Subject: **STALLING/HESITATION/LOW POWER/WHITE SMOKE
(CHECK LIFT PUMP/CONDITION: NEW OIL PRESSURE
SENDER/SWITCH AVAILABLE)**

Model and Year: **1992-93 C/K TRUCKS WITH 6.5L TURBO DIESEL
(RPO L65) OR 6.2L DIESEL (RPOS LH6 AND LL4)**

THIS BULLETIN CANCELS AND SUPERSEDES DEALER SERVICE BULLETIN NO. 92-309-6A, DATED OCTOBER 1992. THE 1993 MODEL YEAR HAS BEEN ADDED AS WELL AS A NEW OIL PRESSURE SWITCH PART NUMBER AND FURTHER INFORMATION TO THE CORRECTION SECTION. ALL COPIES OF 93-286-6A SHOULD BE DISCARDED.

Figure 1 - Lift Pump Electrical Circuit

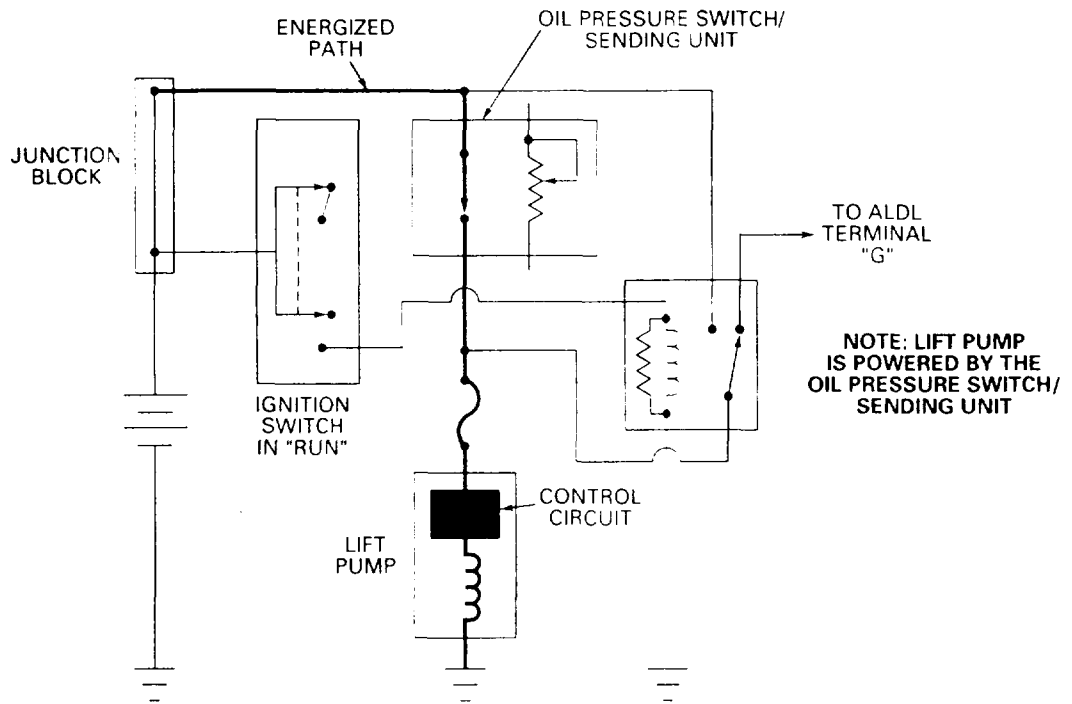
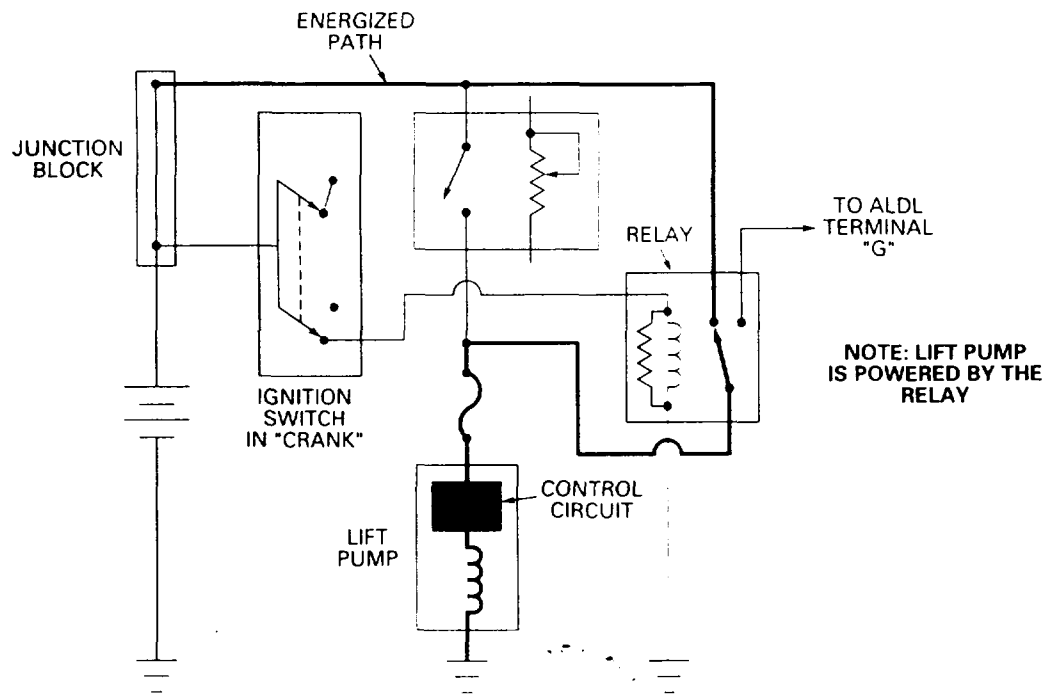
The two circuits powering the lift pump are shown in Figure 1; both circuits need to be checked. Intermittent supply circuit problems may require monitoring the voltage at the lift pump during vehicle operation. This can be accomplished on vehicles equipped with Data Link Connectors (DLC) by probing for voltage at terminal G while the engine is running (charging system functioning properly and batteries fully charged). A difference of more than 1.5 volts between terminal G and battery voltage indicates a problem in the oil pressure switch circuit.

Once diagnosed, the problem is resolved by either replacing the faulty oil pressure sender/switch, the faulty lift pump, or repairing the wiring.
